Project name **Station Hill Phase 1**
 Project no. **1620004716**
 Client **Lincoln MGT**
 To **Reading Borough Council**
 From **Keith Jones**

Storm Water Drainage Supplementary Memo

This memo outlines the minor modifications proposed to the storm water drainage network, the compliance with the approved drainage strategy and the status of the installed drainage prior to occupation of the first units in Block E.

**BLOCK E & F
PROPOSED SURFACE WATER
DRAINAGE LAYOUT
SHEET 2 OF 2**

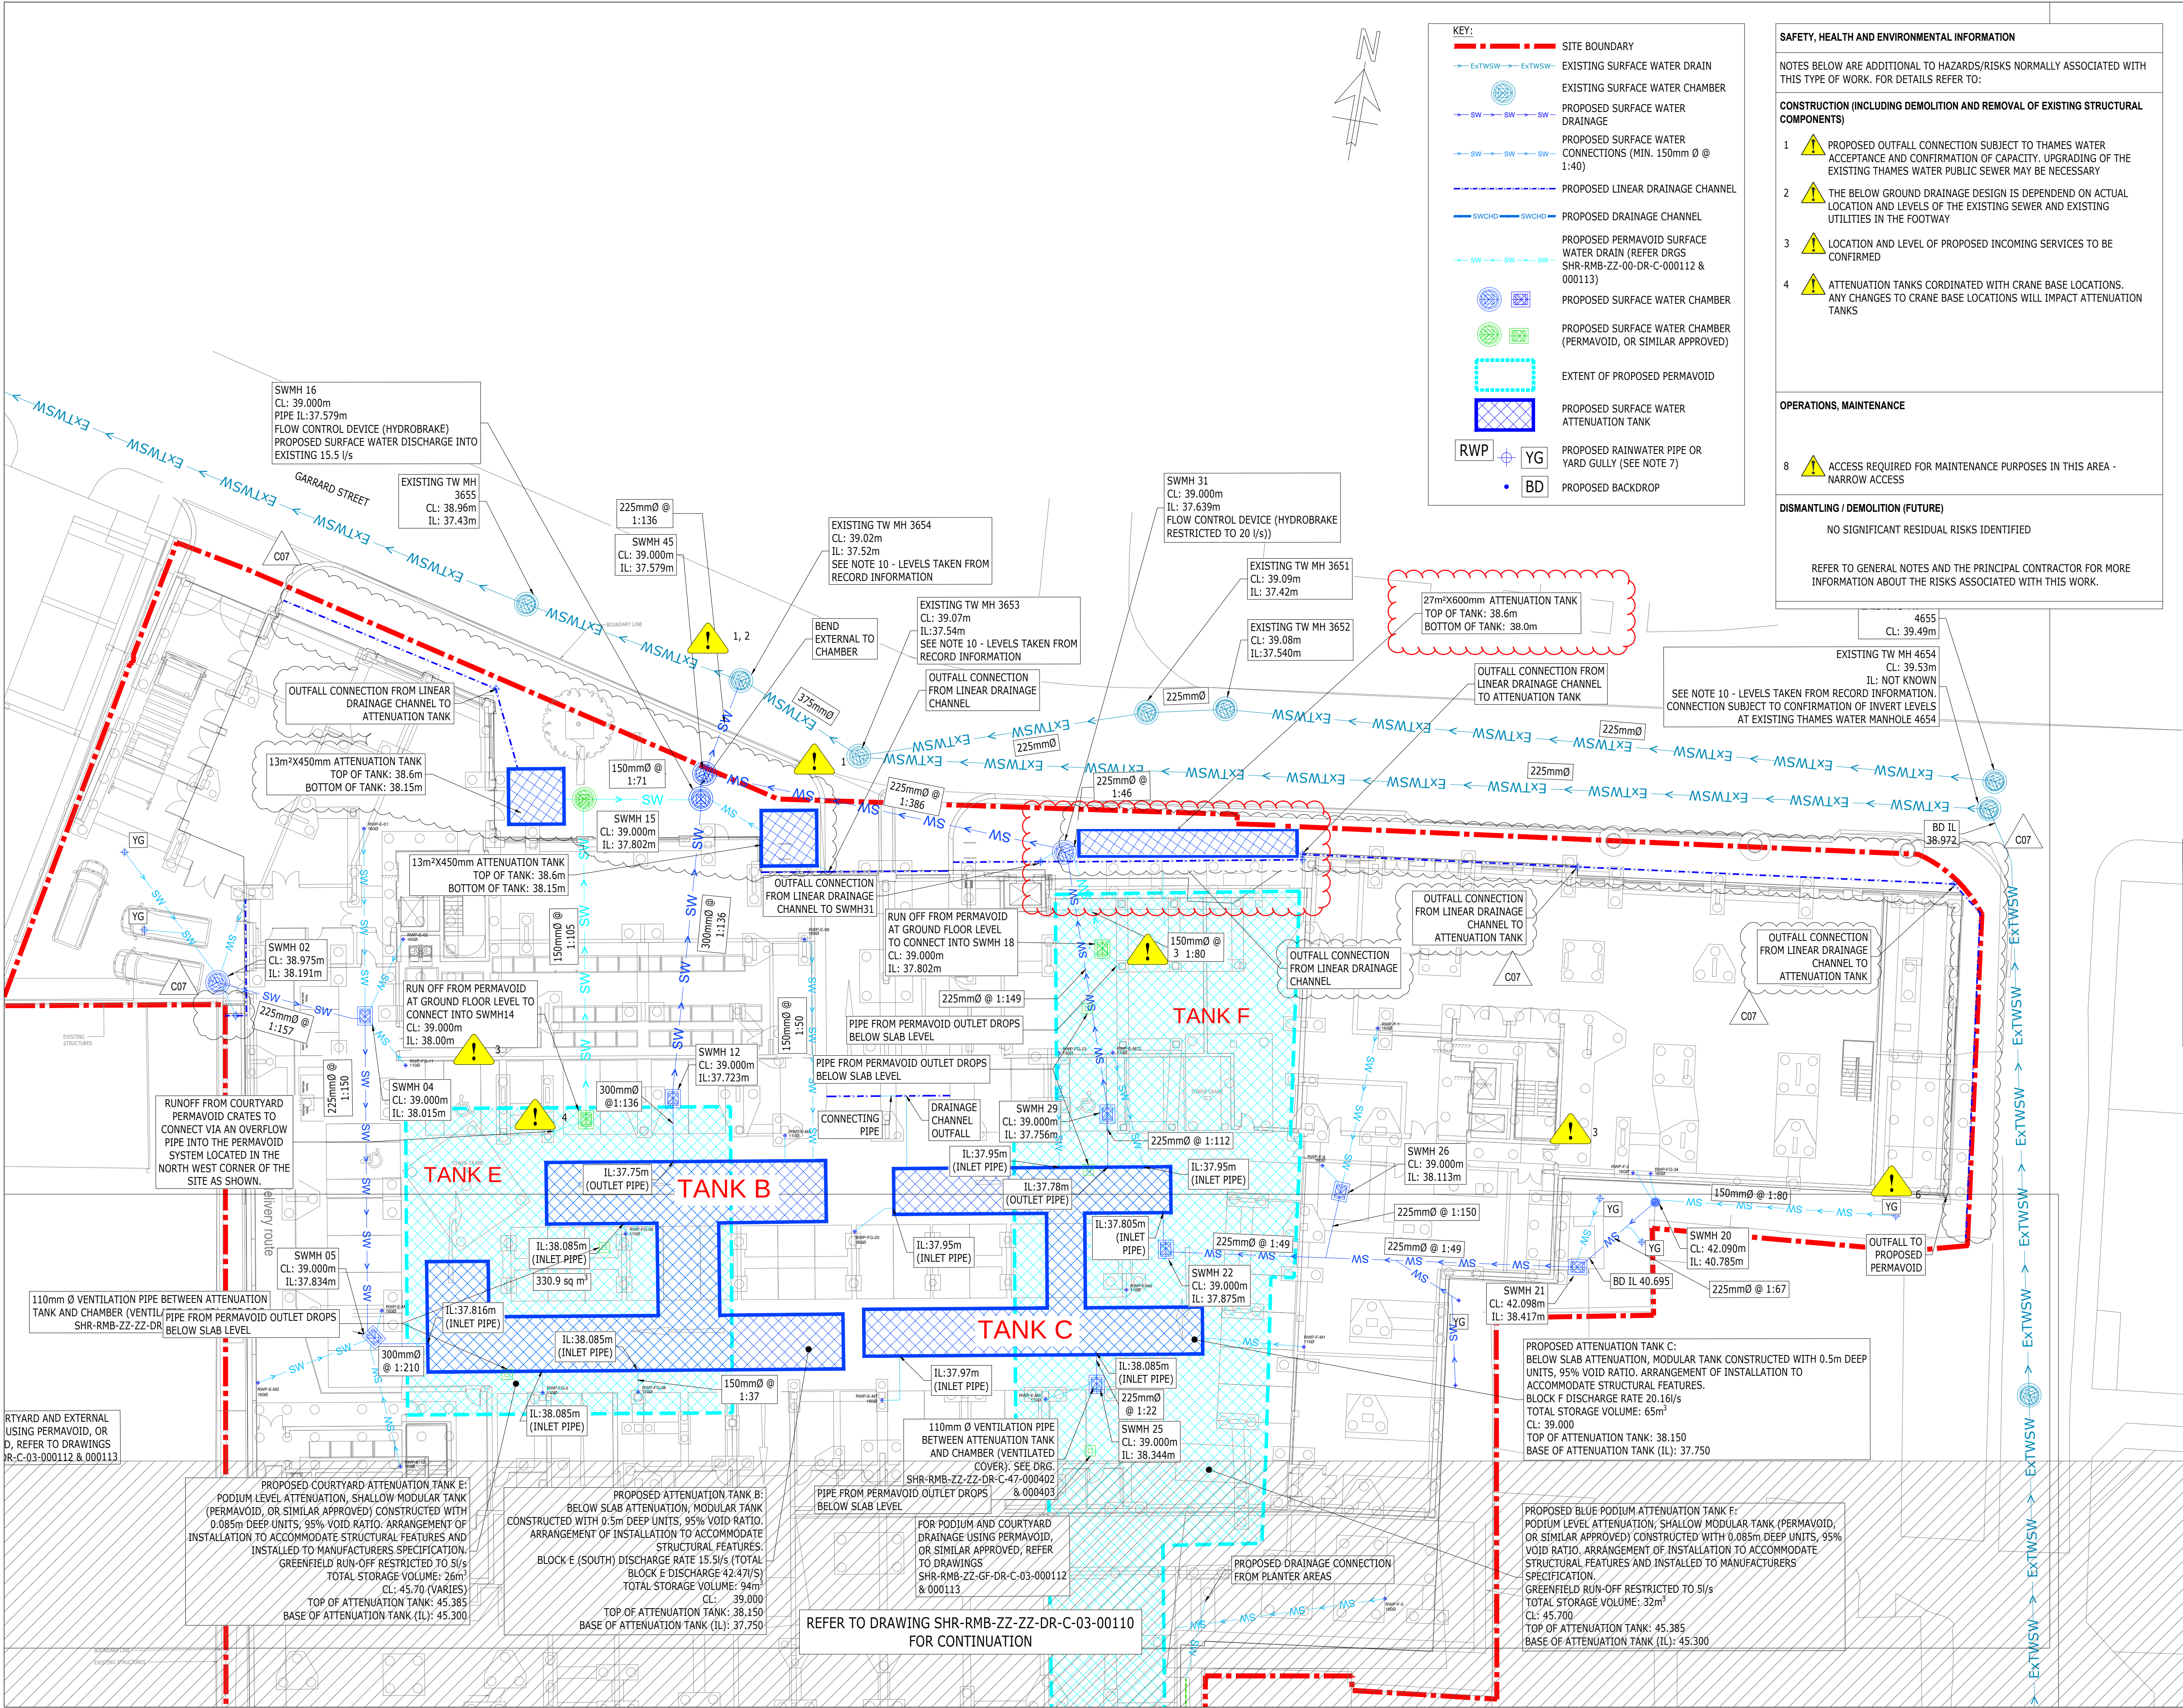
The final construction issue version of the storm water drainage drawings included the 6 tanks described above with the attenuation volumes identical for tanks A to D and slightly larger for tanks E to F.

Tank	Attenuation Volume (m ³)
A	68
B	94
C	65
D	48
E	26
F	32

The are shown on the attached drawings at the end of this memo. The Contractor Midgard has installed these 6 tanks and a confirmation email is provided.

In addition to the 6 tanks, additional shallow attenuation (permavoid or similar) under the pavement areas of Garrard Street was shown on the drawings included in the Drainage Strategy report. However, these areas were not included in the hydraulic model as attenuation and were primarily provided as a method of collecting the water if permeable paving was adopted.

The subsequent design development of Garrard Street has resulted in the pavement being drained via slot drains and gulley points. The volume of the Garrard Street shallow attenuation has been replaced with 3 attenuation tanks of similar volume. Thus there is no fundamental change to the storm water drainage network as set out in the approved drainage strategy report.
